Exhibit L

DATE: August 4, 2022

SUBJECT: Public Works Conditions of Approval
T-6345 / P22-01027 a 199-lot single family subdivision
2121 South Willow Avenue
D.R. Horton CA3, Inc / QK

The Public Works Department, Traffic Operations and Planning Division, has completed its review and the following requirements are to be placed on this tentative map as a condition of approval by the Public Works Department.

NOTE: THIS MAP IS SCHEMATIC. DISTANCES, AMOUNT OF CREDITABLE FACILITIES, AND LOCATION OF INLET BOUNDARIES ARE APPROXIMATE.

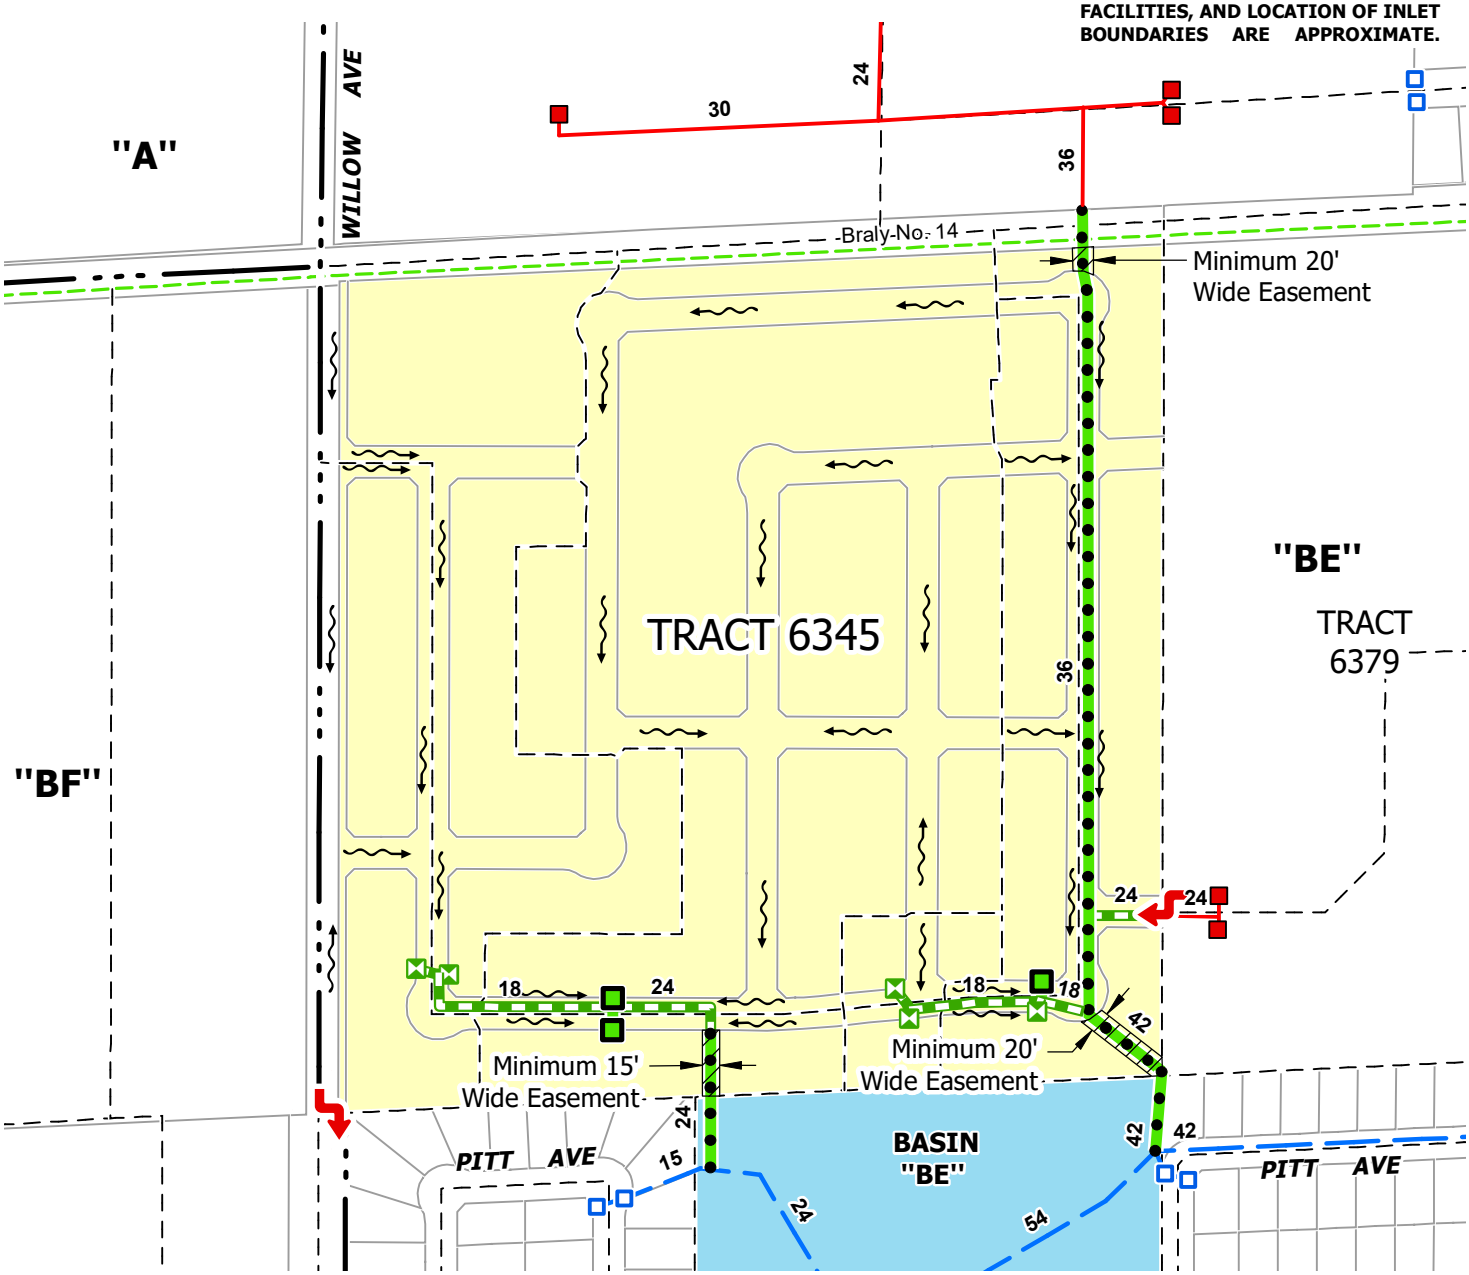
_X_ Developer shall construct facilities as shown on Exhibit No. 1 as MASTER PLAN FACILITIES TO BE CONSTRUCTED BY DEVELOPER.

NOTE: THIS MAP IS SCHEMATIC. DISTANCES, AMOUNT OF CREDITABLE FACILITIES, AND LOCATION OF INLET BOUNDARIES ARE APPROXIMATE.

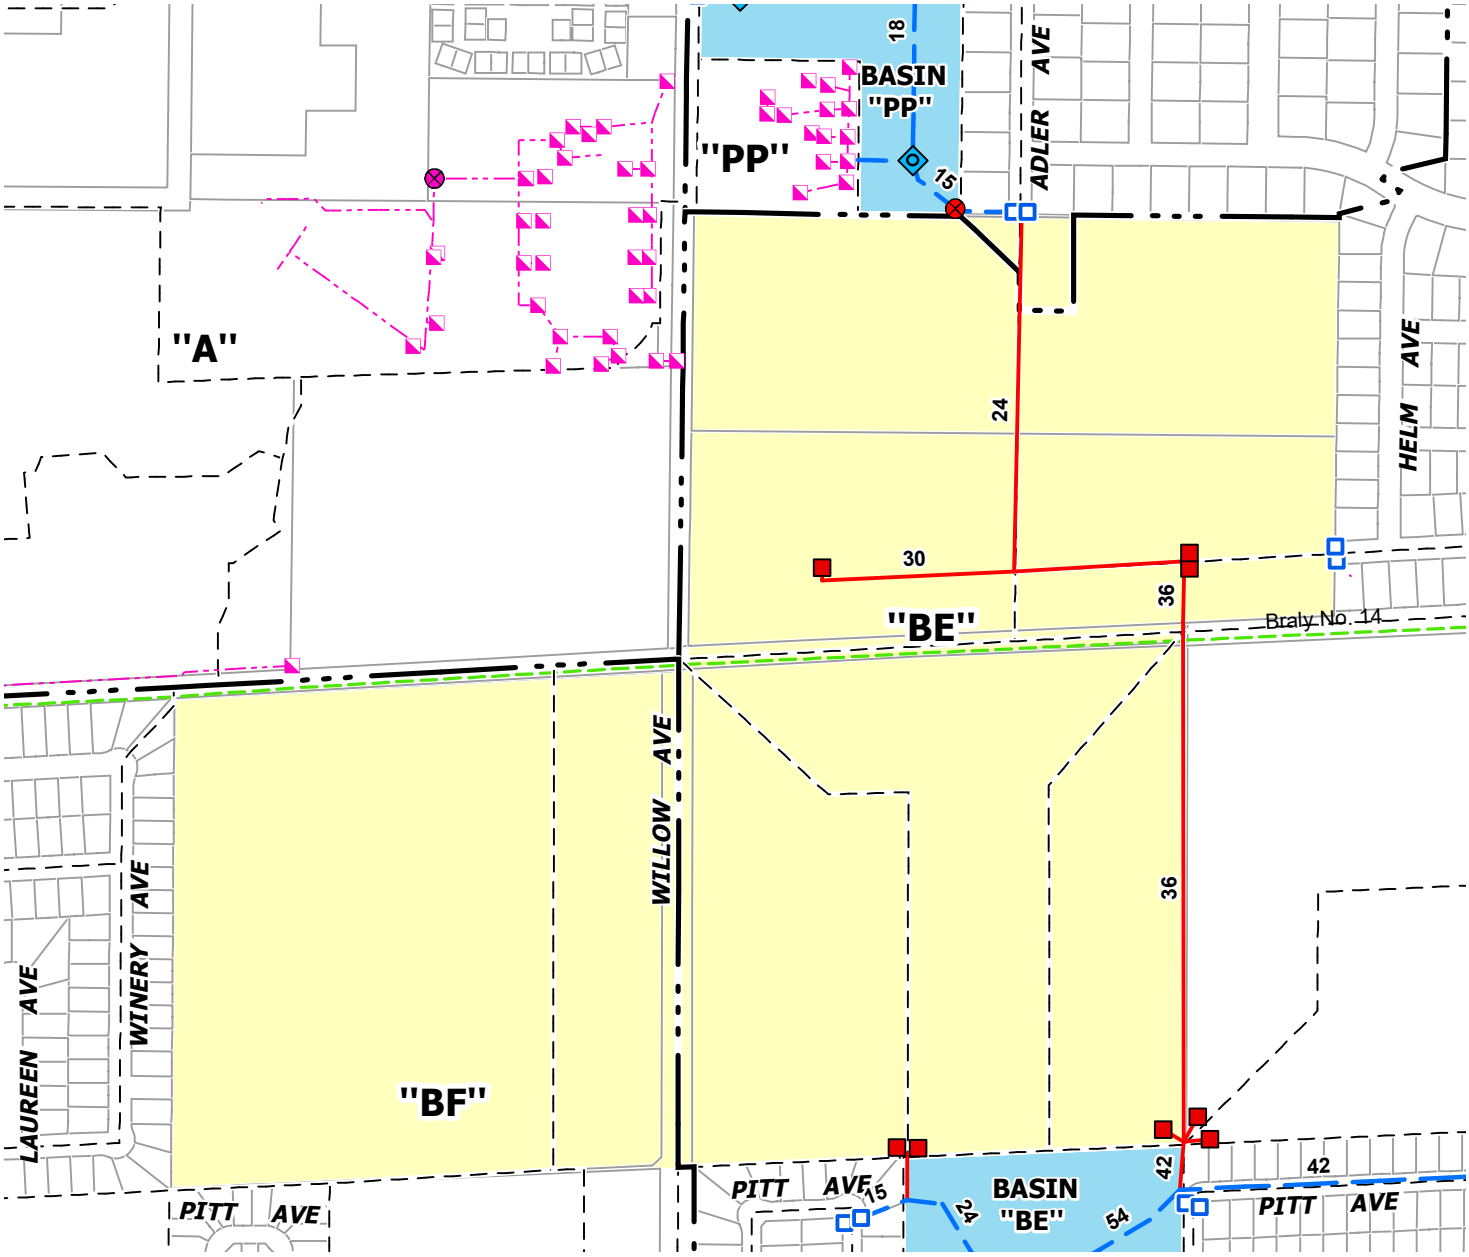
The District has reviewed the land use changes proposed through the subject rezone and plan amendment. The proposed rezone and plan amendment lies within the District's Drainage Areas "BE", "BF", and "PP" as shown on Exhibit No. 1.

The District's system, located within Drainage Area "BE", east side of Willow Avenue, can accommodate the proposed rezone and plan amendment.

The portion of the rezone located within Drainage Areas "BF" and "PP", when developed, will be required to mitigate the impacts of the increased runoff from medium density residential land use to a rate that would be expected if developed to a medium-low density residential land use. The development may either make improvements to the existing pipeline system to provide additional capacity or may use some type of permanent peak reducing facility in order to eliminate adverse impacts on the existing system. Implementation of the mitigation measures may be deferred until the time of development.
